**RE: Grading and Drainage Plan for Lot 437, Sandia Heights South Unit 4 (C23/D56)
(PWD-98-47) Engineer's Stamp Dated 3/9/98.**

Based on the information provided with the submittal of March 10, 1998, the plan for the above referenced Lot is approved for Building Permit release.

GRADING AND DRAINAGE PLAN
LOT 437 LIVE OAK LOOP
SANDIA HEIGHTS SOUTH UNIT 4
ADDITION TO HOUSE

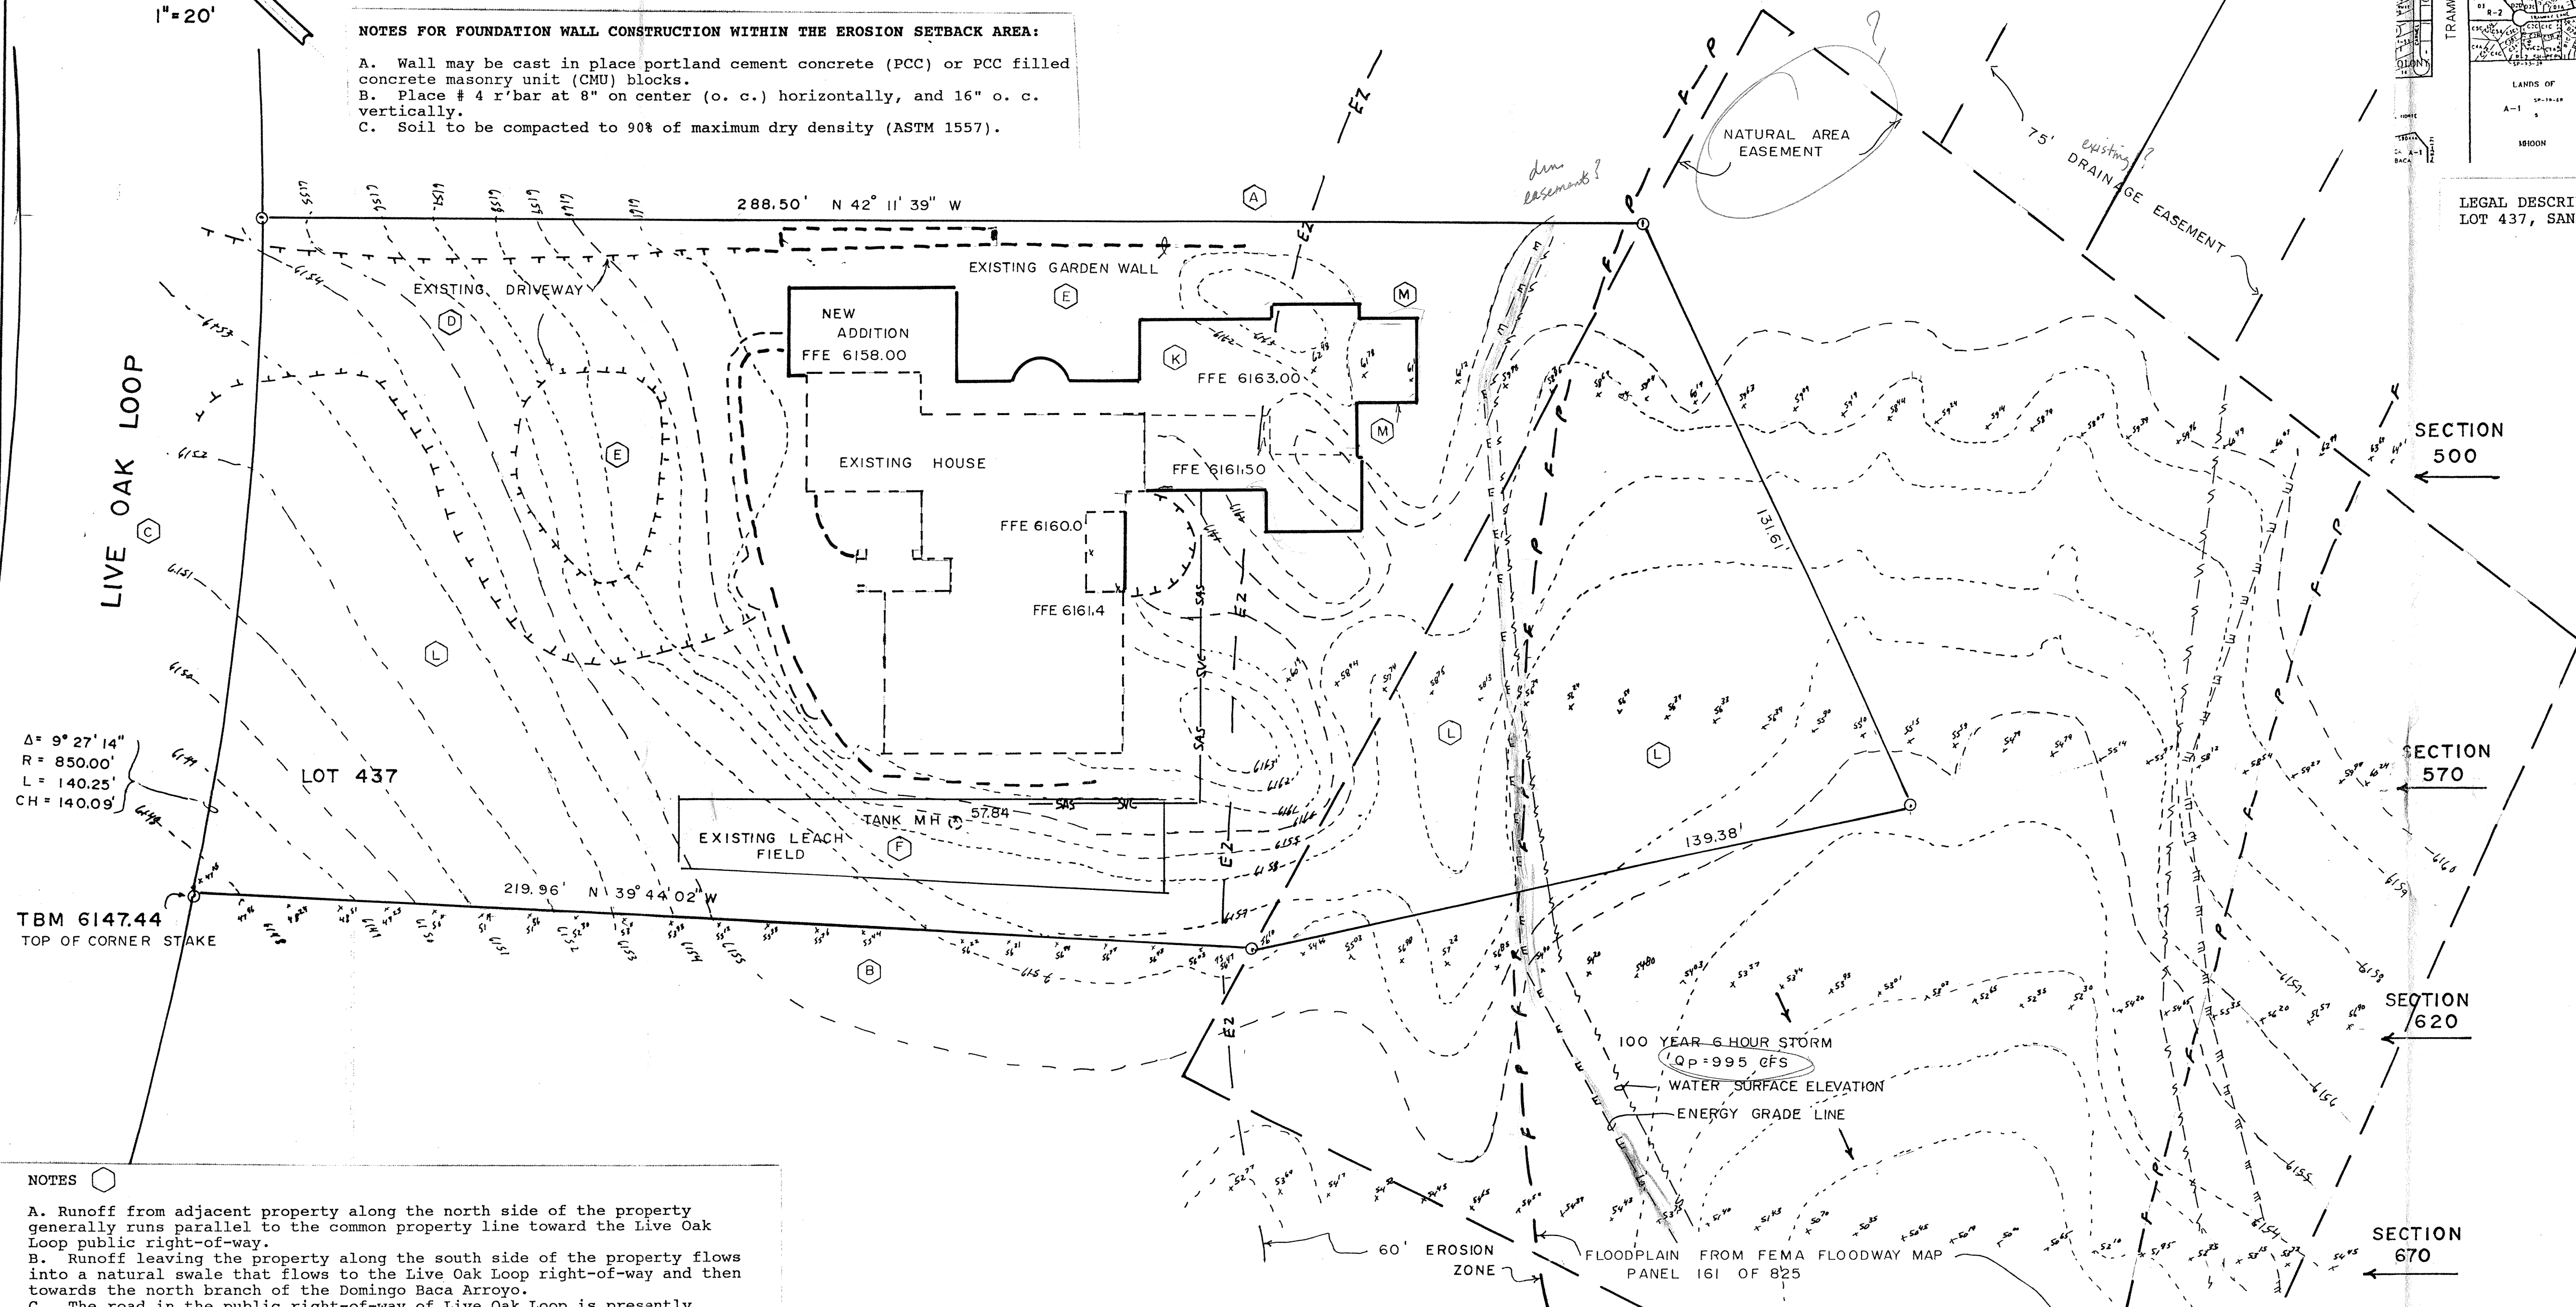
As you are aware, the Engineer's Certification must be submitted to and approved by the County and my office prior to release of the Certificate of Occupancy for this residence. It is very important that the depth of the foundation wall for the construction within the erosion setback be certified.
